Assessment number 2320

Ashburton Infrastructure Project – Responses to the Public Review Period

Please find Mineral Resources Limited's (MinRes) responses to submission's on the **Ashburton Infrastructure Project** comments received from Department of Water and Environmental Regulation - EPA Services (DWER-EPAS) via email on the 19 August 2022 and 30 August 2022.

Figure 7 1: Existing and Proposed Construction Ecological Protection Areas for the Proposal

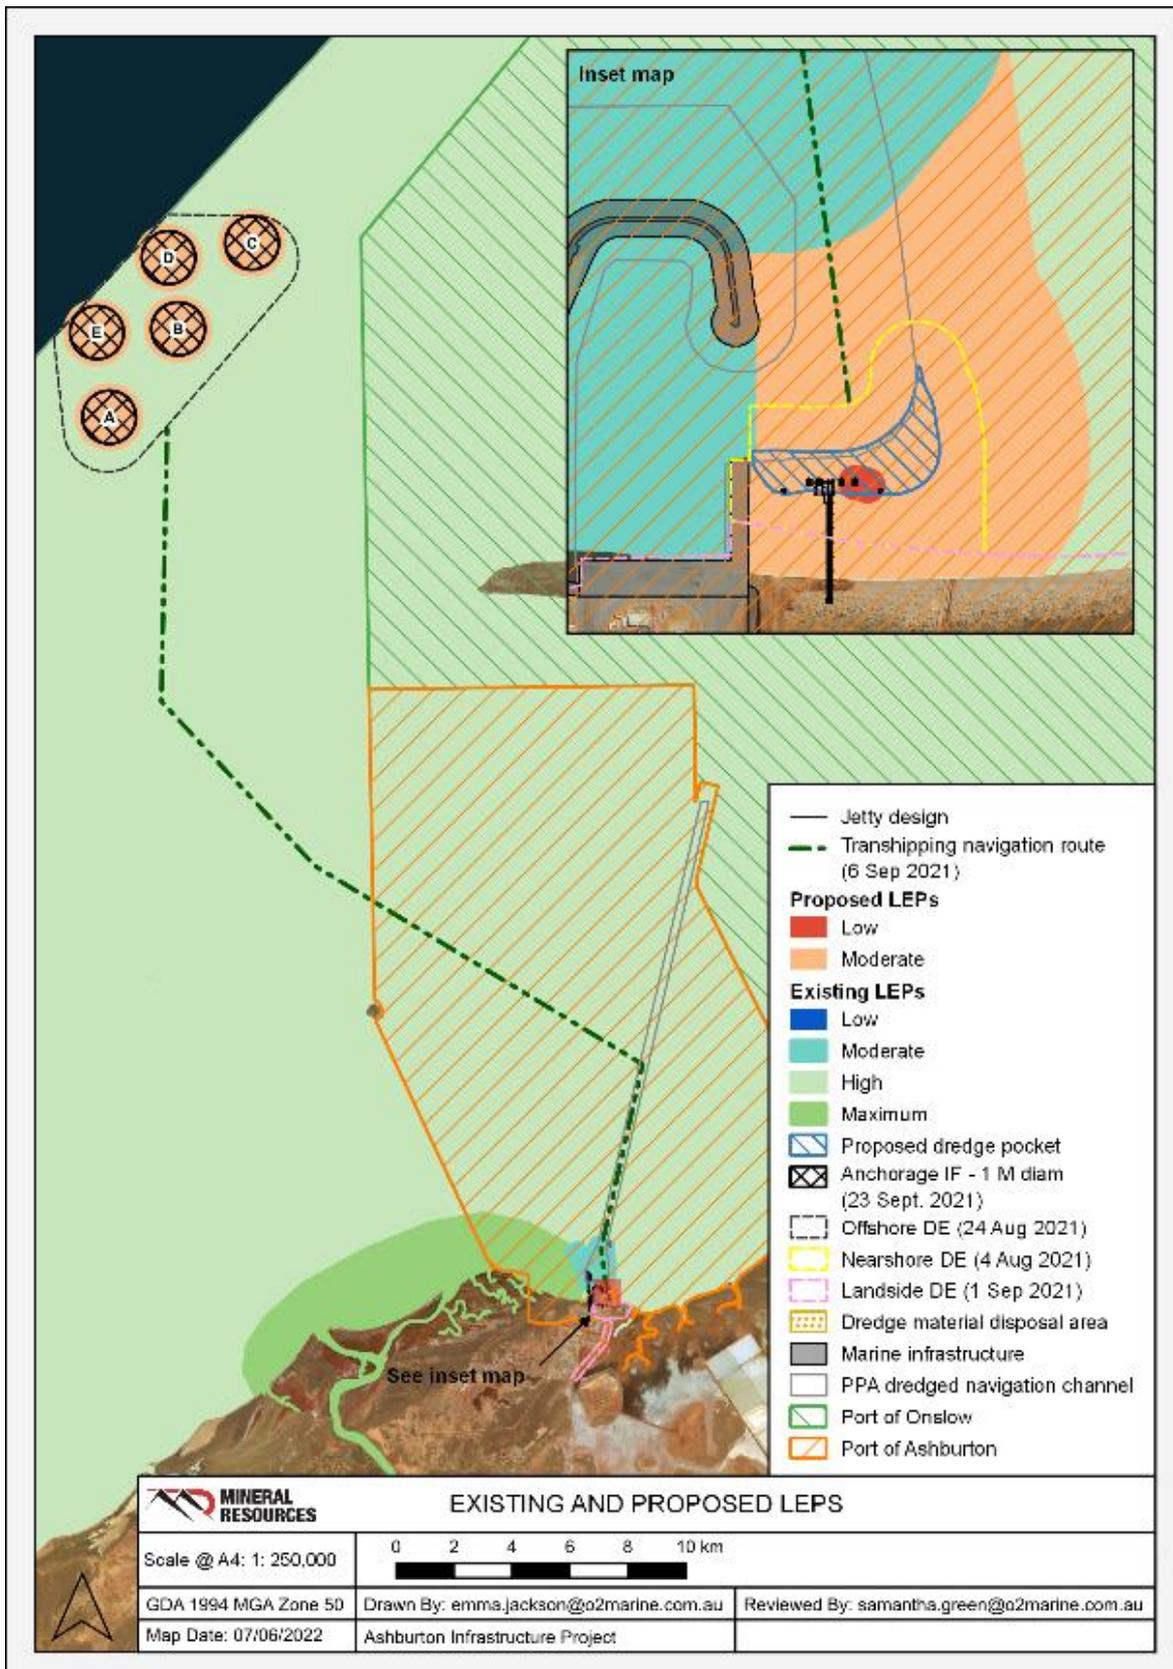
No.	Submitter	Submission and/or issue	Response to comment
9	#3	The Marine Operational Environment Management Plan (MOEMP) should have a more expansive sampling program to the east given the general tidal movement.	Noted – The MOEMMP (Appendix D) has been reviewed by EPA, PPA and DCCEEW and revised to incorporate their requirements.
10	#6	The Proponent should still provide a map with the existing discharge locations (e.g., Wheatstone LNG facility and Onslow Salt waste brine outfall) and the respective levels of ecological protection zones.	Figure 7 1: Existing and Proposed Construction Ecological Protection Areas for the Proposal (see Section 7.6.2.3 , pg. 104), displays the existing Low EPs, and the proposed combined Low EPs (see Attachment 1).
